1
	8802-3/802.3 REVISION REQUEST 1163	
+-----+-----+		3
		4
DATE:	30th March, 2005	5
NAME:	Yair Darshan	6
COMPANY/AFFILIATION:	PowerDsine	7
E-MAIL:	yaird@powerdsine.com	8
		9
REQUESTED REVISION:		10
STANDARD:	IEEE Std. 802.3af-2003	11
CLAUSE NUMBER:	33.2.3.1	12
CLAUSE TITLE:	Overview	13
		14
PROPOSED REVISION TEXT:		15
		16
Clause 33.2.3.1 last paragraph		17
		18
Replace the following text:		19
		20
If a PSE performing detection using Alternative A detects an invalid signature, it should initiate a second detection attempt within 1 second after the beginning of the first detection attempt.		21
		22
		23
This ensures that a PSE performing detection using Alternative A will complete a second detection cycle prior to a PSE using Alternative B that might also be present on the same Link Section, and therefore causing the invalid signature, completing its second detection cycle due to the Alternative B detection backoff described above.		24

Figure 33C.1.11-a:
PSE A may complete
detection within more
than two detection
attempts

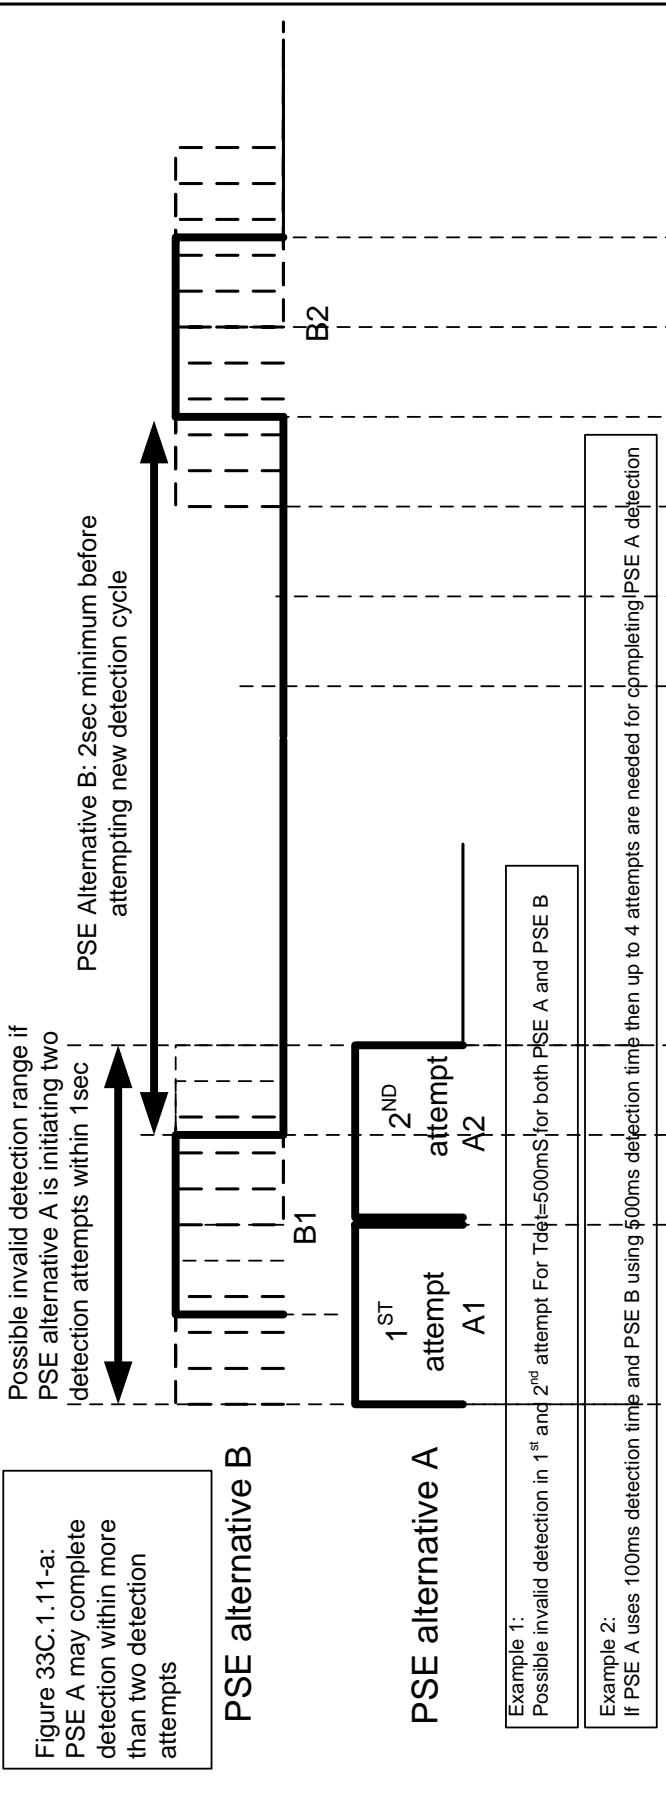
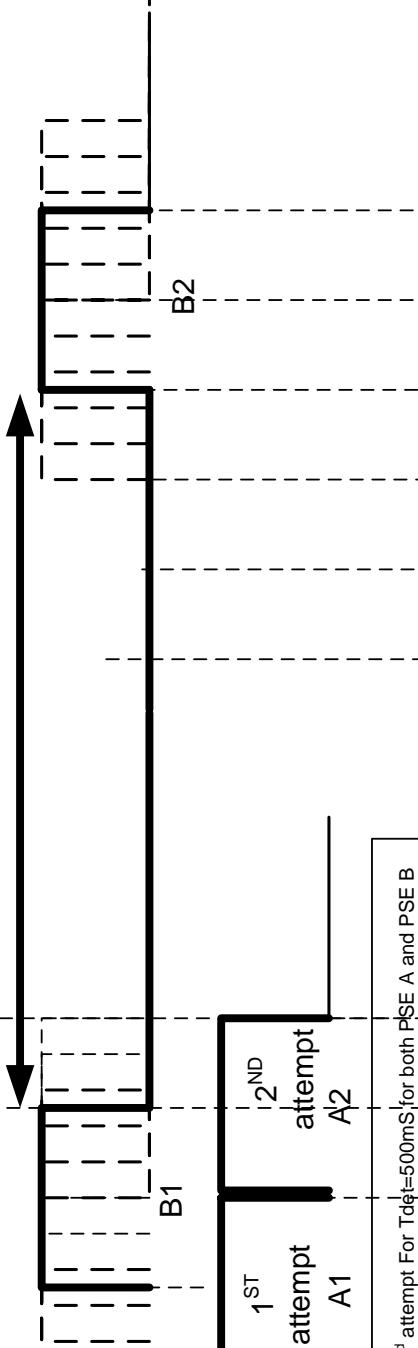
According to the current text, detection may be completed at the 3rd
detection attempt (or even with more attempts if PSE alternative A is
using detection timing shorter than PSE that using alternative B) and not
in the 2nd attempt. 4
5
6
7
8

Possible invalid detection range if
PSE alternative A is initiating two
detection attempts within 1 sec

Example 1:
Possible invalid detection in 1st and 2nd attempt For Tdet=500ms for both PSE A and PSE B

Example 2:
If PSE A uses 100ms detection time and PSE B using 500ms detection time then up to 4 attempts are needed for completing IPSE A detection

25
		26
		27
		28
		29
with:		30
		31
		32
If a PSE performing detection using Alternative A detects an invalid signature, it should complete a second detection attempt within 2 sec after the beginning of the first detection attempt.		33
		34
		35
		36
This allows that a PSE performing detection using Alternative A will complete a detection cycle within reasonable number of attempts prior to a PSE using Alternative B that might also be present on the same Link Section, and therefore causing the invalid signature, completing its second detection cycle due to the Alternative B detection backoff described above.		37
		38
		39
		40
		41
		42
		43
Add figure 33C.12.1-a and 33C.12.1-b to 33C.1.11		44
		45
		46
RATIONALE FOR REVISION:		47
		48
See attached figures 33C.12.1 for illustration of the problem and its solution.		49
		50
		51
The old text containing the word "beginning" in PSE alternative A is an error due to the fact that the intent per the current text was to initiate new detection cycle, with a time delay after the 1st attempt in		52

The revision that is proposed above, fix the confusion, allow the use of
the current timing, allows completing detection in the 2nd attempt with
flexible delay time and not limiting the number of attempts done by PSE A
until completing the detection prior to PSE B initiating its 2nd
attempt. 9
10
11
12
13
14

Figure 33C.1.11-b:
PSE A may complete
detection at the 2nd
attempt

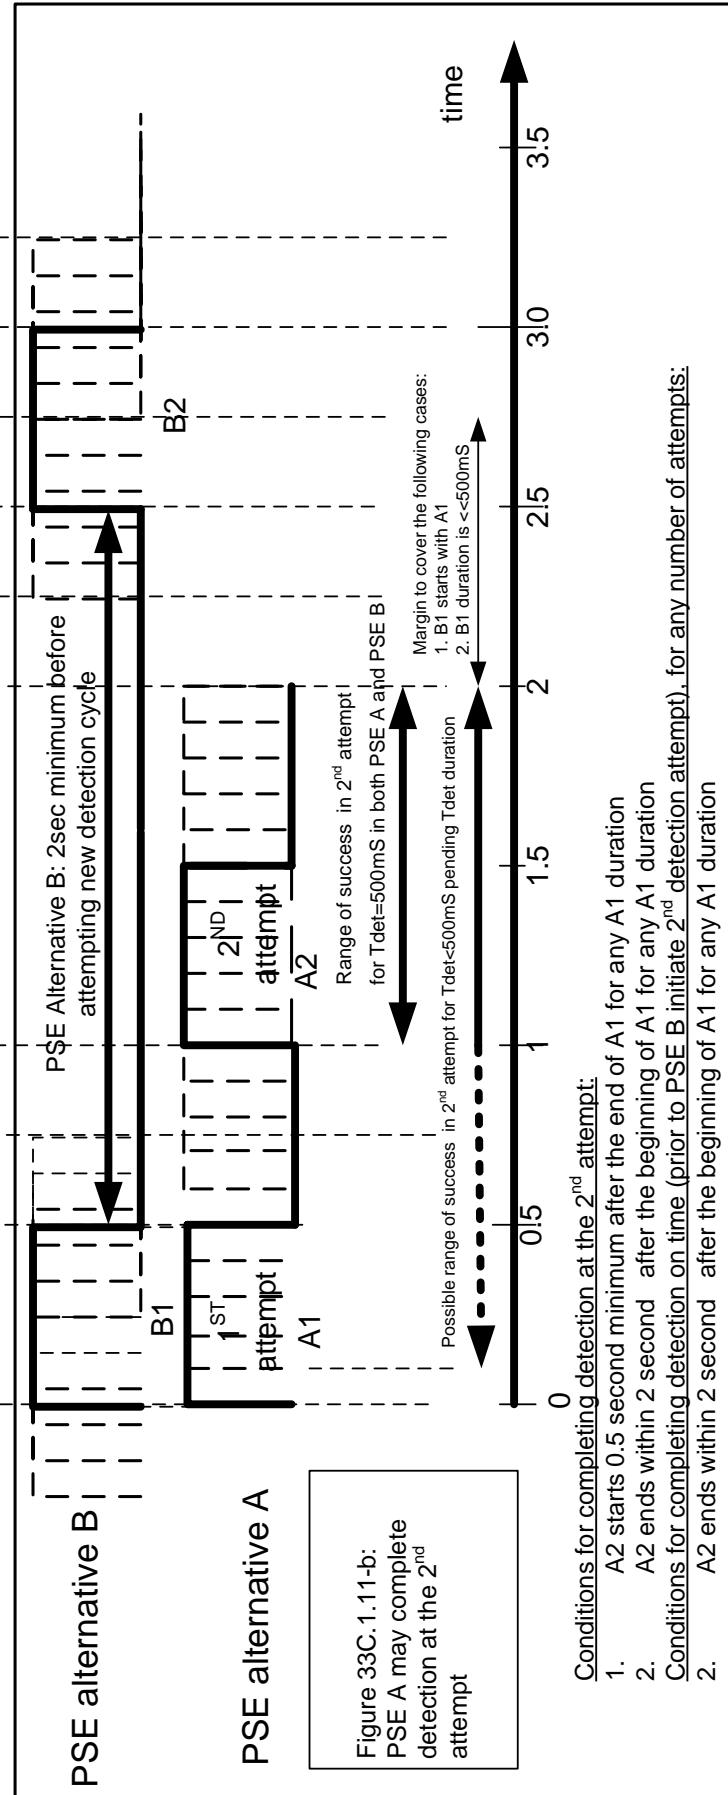
Conditions for completing detection at the 2nd attempt:

1. A2 starts 0.5 second minimum after the end of A1 for any A1 duration
 2. A2 ends within 2 second after the beginning of A1 for any A1 duration
- Conditions for completing detection on time (prior to PSE B initiate 2nd detection attempt), for any number of attempts:
1. B1 starts with A1
 2. B1 duration is <500ms
